Addendum Number: 02

Addendum Issue Date: April 21, 2026

Project Name: CMH – Consulting Clinic Expansion

Project Number: 02500690.001

M5.4

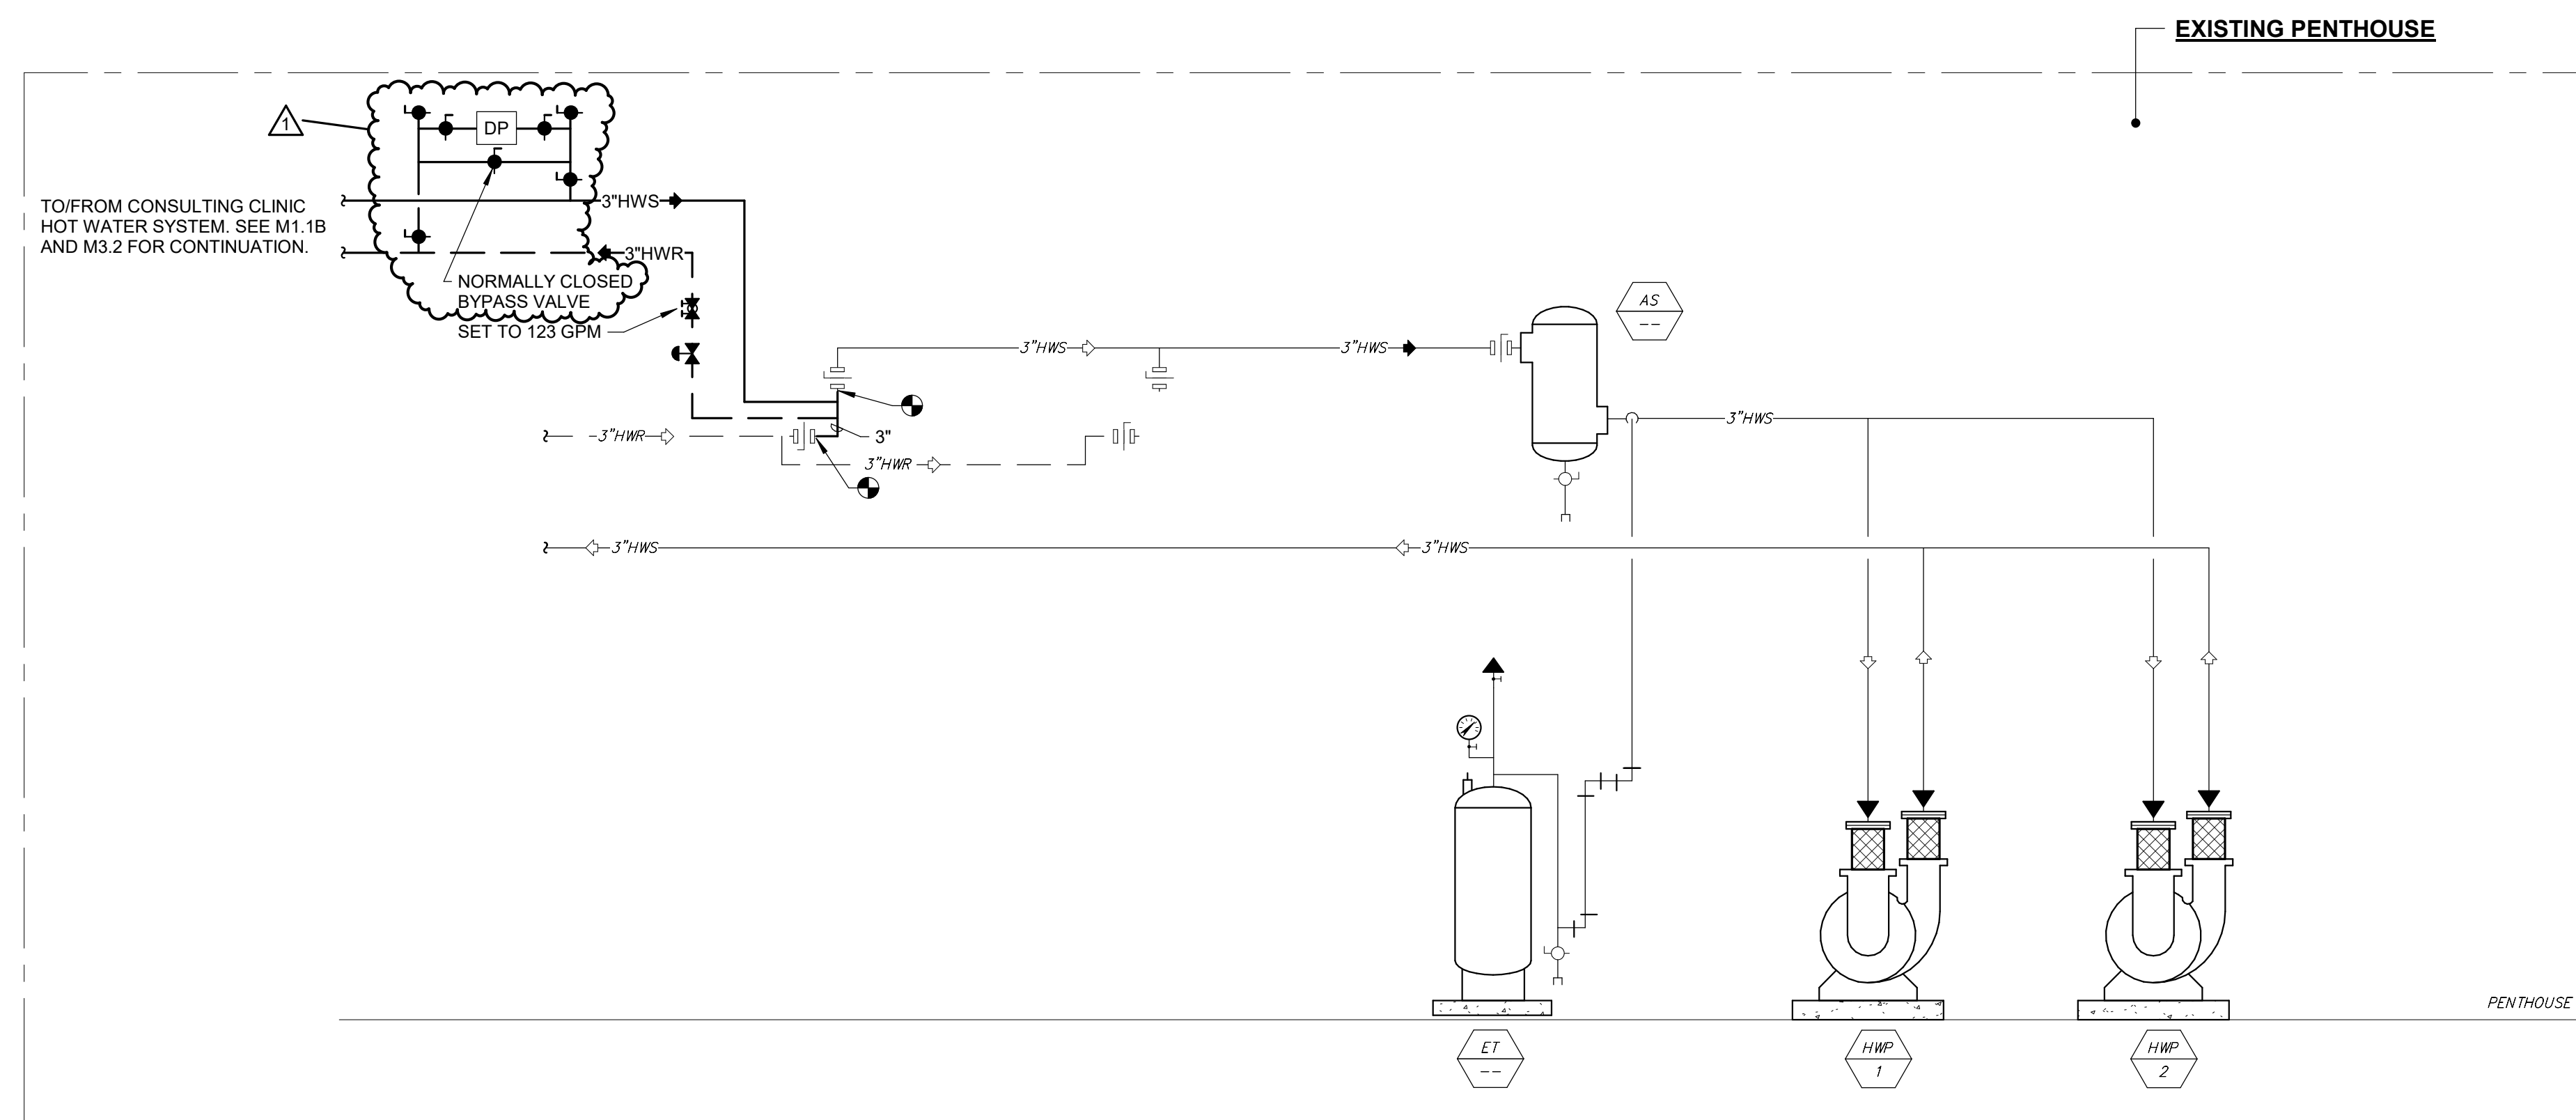
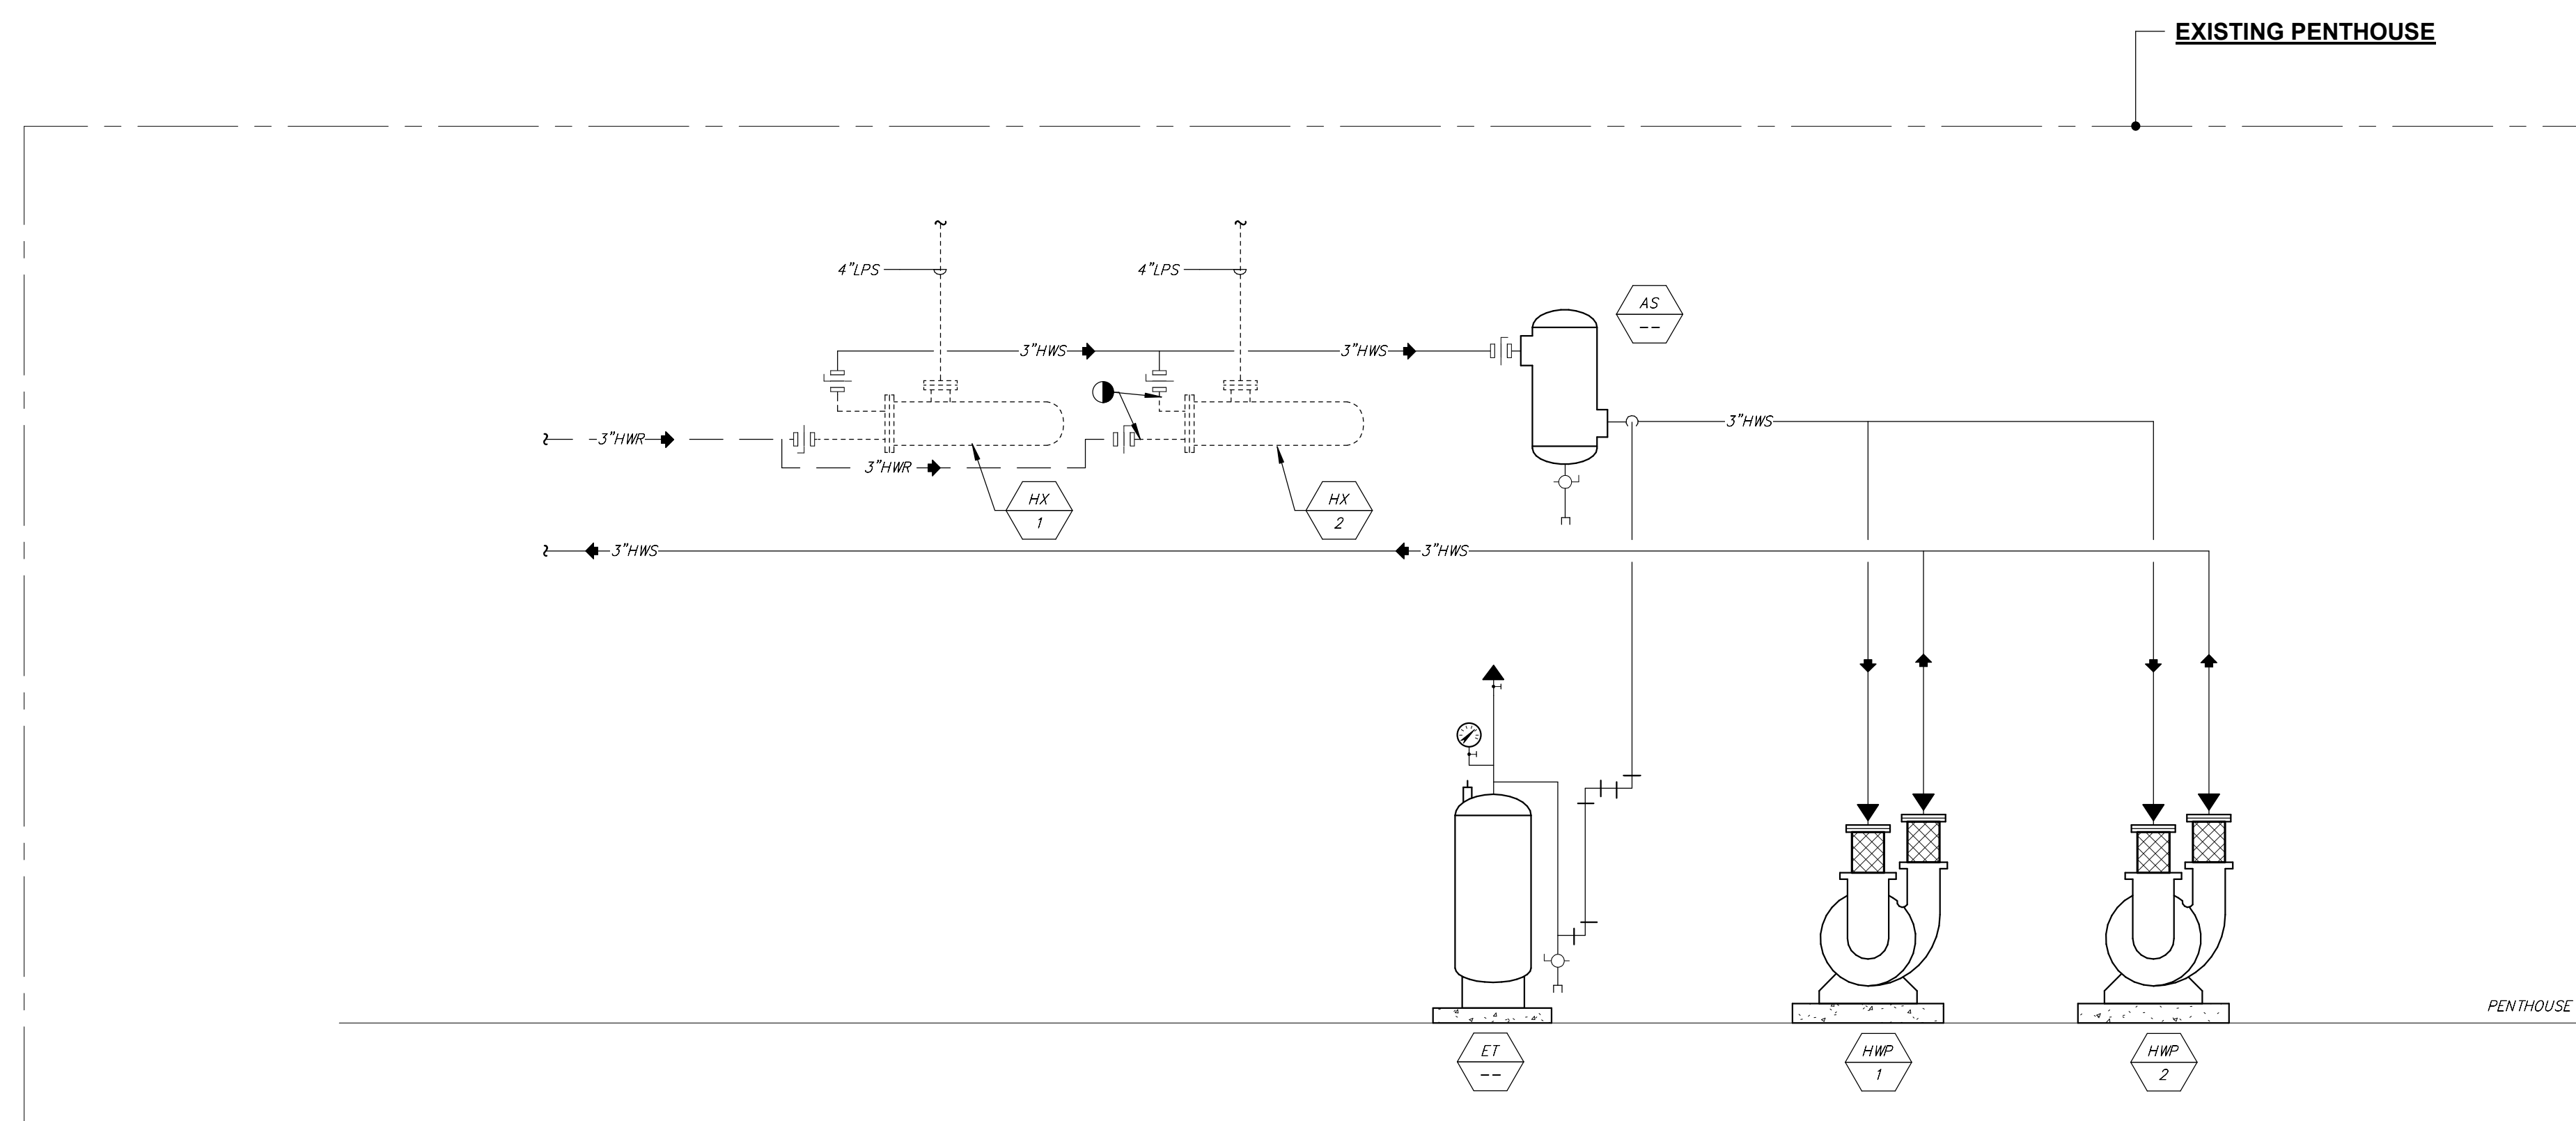
1. Sheet A7.3 – DOOR SCHEDULE
 - a. REVISE door width of SC112-2 to be 4'-0" in lieu of 3'-8" as shown.
2. Sheet M3.1 – ENLARGED PLANS
 - a. ADD motorized dampers serving louvers L-1 and L-2 in first and second floor mechanical rooms. See new keynotes 7 and 8 for clarification.
3. Sheet M3.2 – ENLARGED PLANS
 - a. REVISE keynotes 1, 4, 5, 6, and 8 as shown for clarification.
 - b. ADD keynote 9.
4. Sheet M5.3 – DIAGRAMS
 - a. REVISE Heating Water Flow Diagram – Primary/Secondary to ADD heat exchanger isolation valves as indicated on attached M5.3.
5. Sheet M5.4 – DIAGRAMS
 - a. REVISE Diagram as indicated on attached M5.3.

M6.1

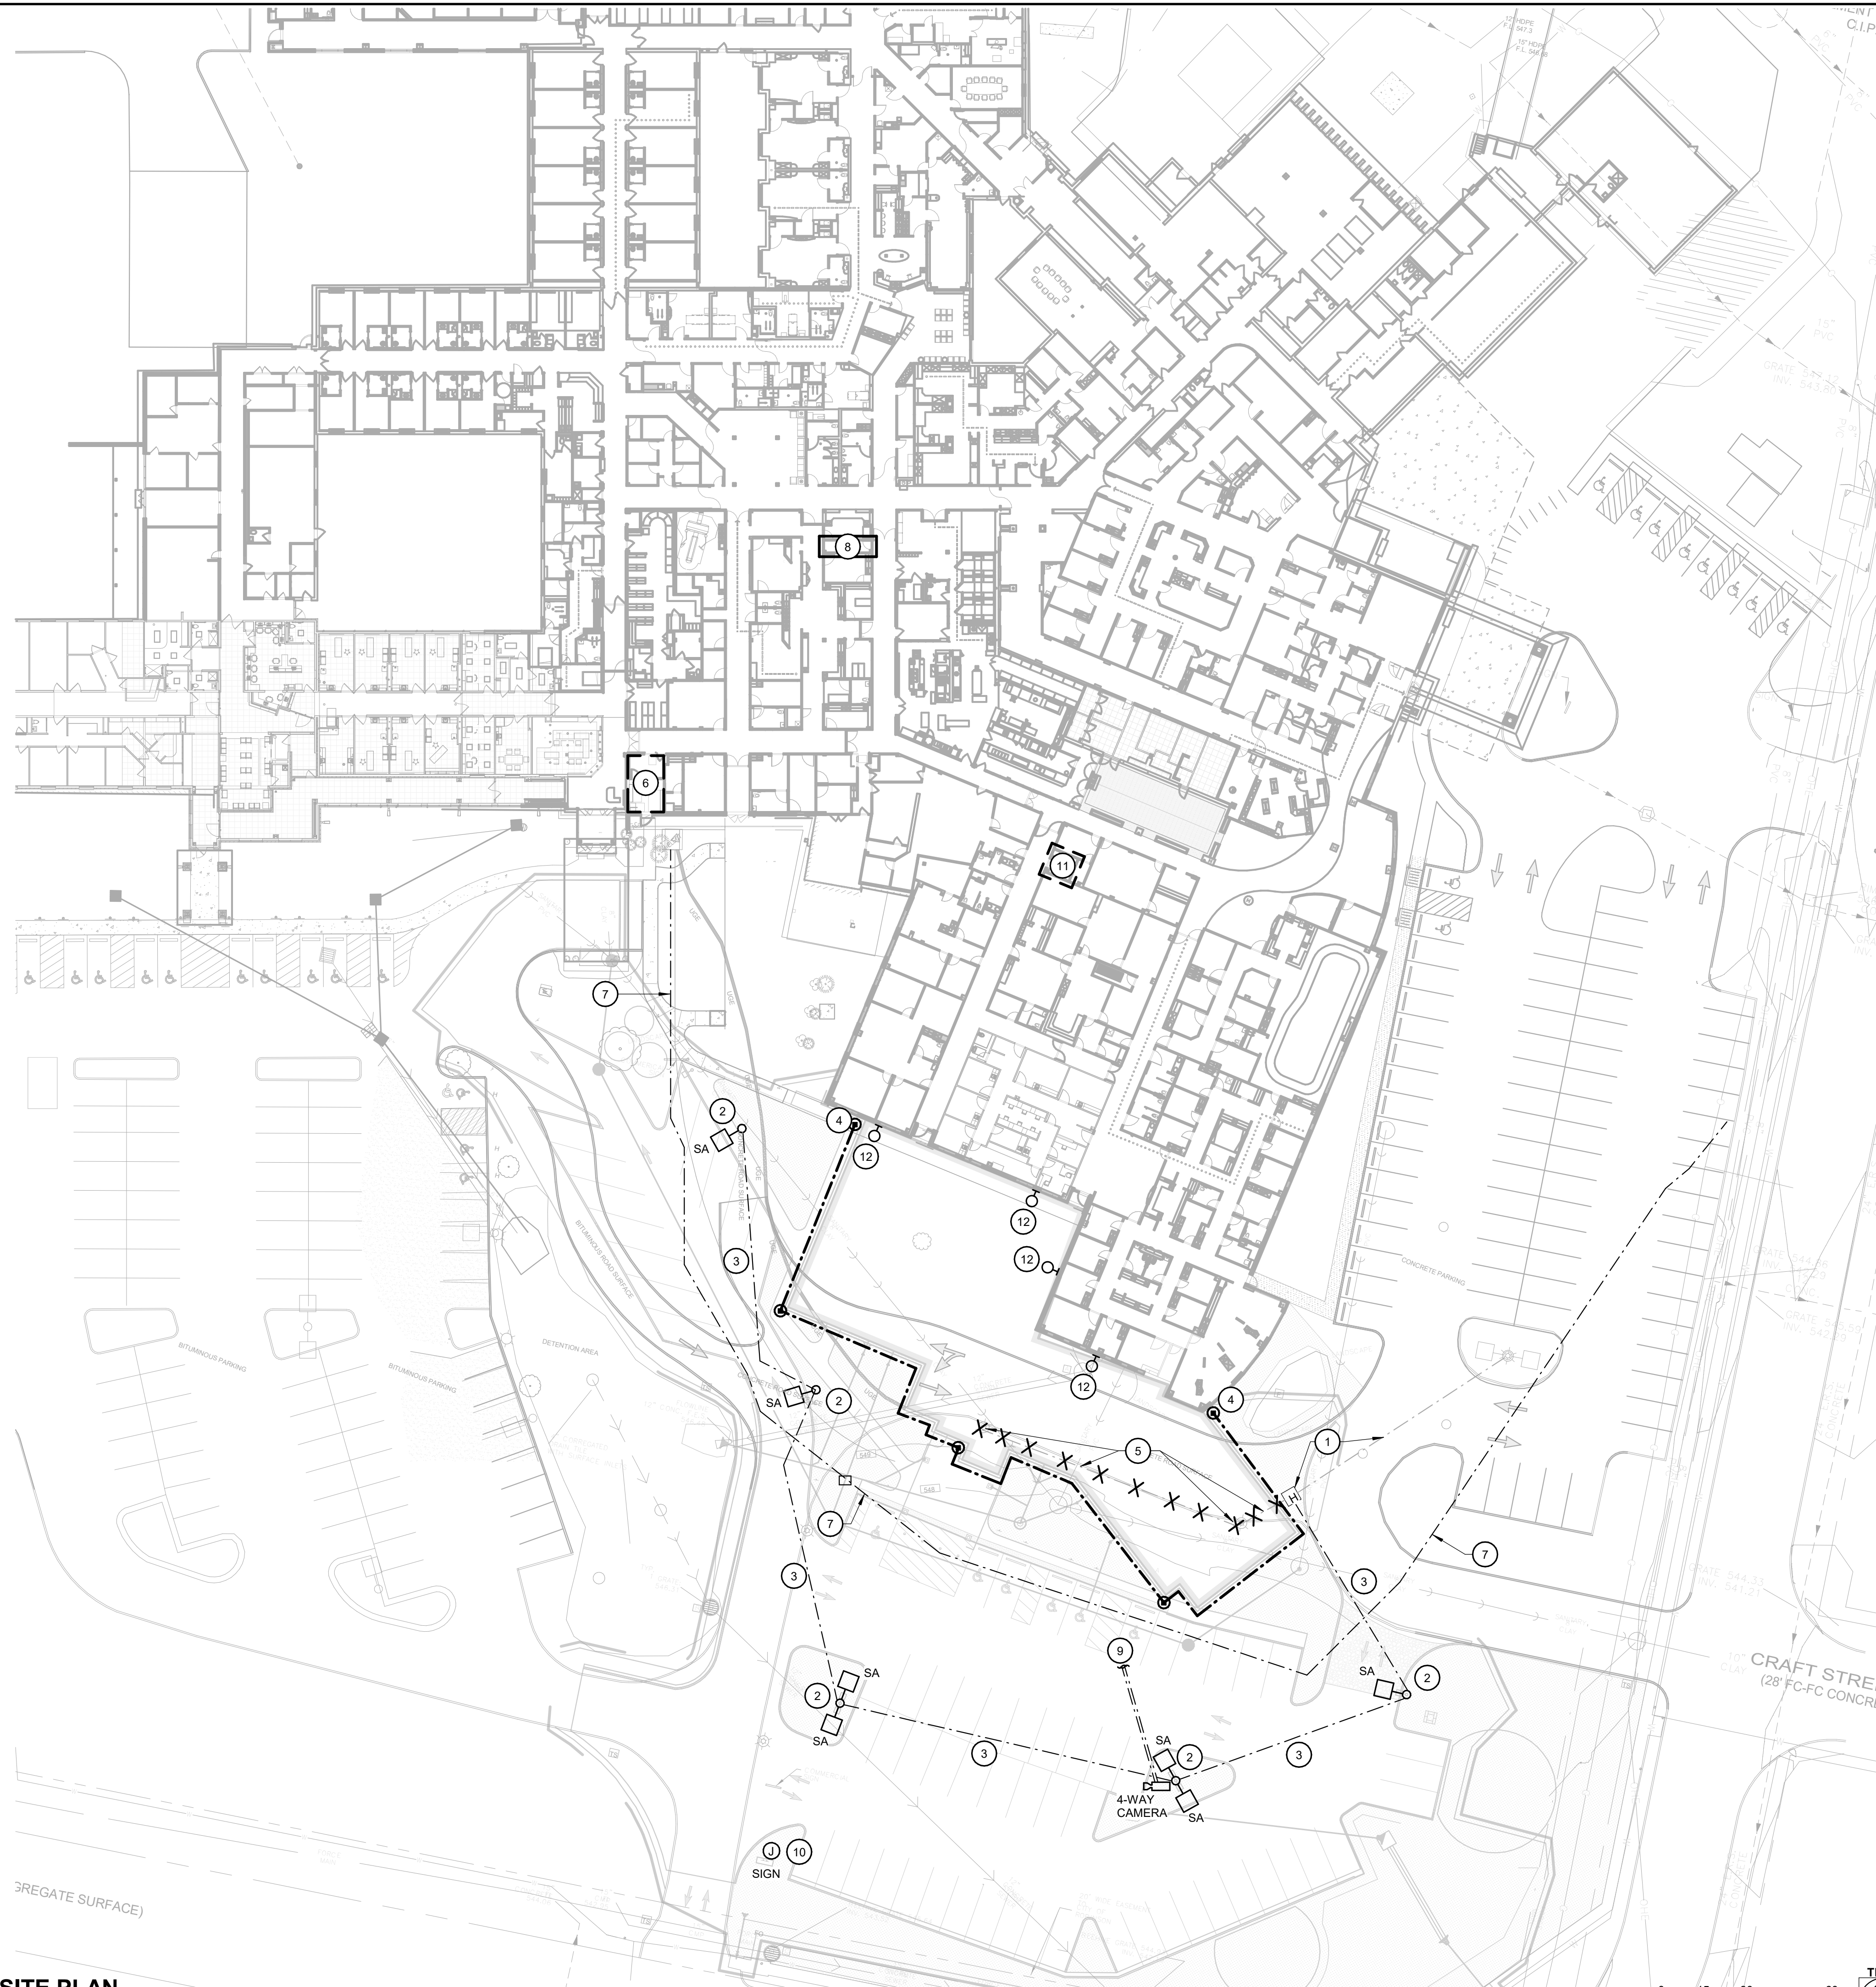
6. Sheet M6.1 – SCHEDULES
 - a. ADD louver schedule.
7. Sheet M7.4 – DIAGRAMS
 - a. REVISE as indicated on attached M7.4.
8. Sheet ES1.1-ELECTRICAL SITE PLAN
 - a. REVISED Enlarged View -Electrical Room background.
9. Sheet E1.1-FIRST FLOOR LIGHTING PLAN
 - a. REVISED Clinic rooms with dimmers Fixture type.
10. Sheet E1.2-SECOND FLOOR LIGHTING PLAN
 - a. REVISED Clinic rooms with dimmers Fixture type.
11. Sheet E2.2-SECOND FLOOR POWER PLAN
 - a. ADD Poke-Thru floor fitting manufacturer and model number.
 - b. ADD above ceiling boxes and conduit work for future installation of signage by others.
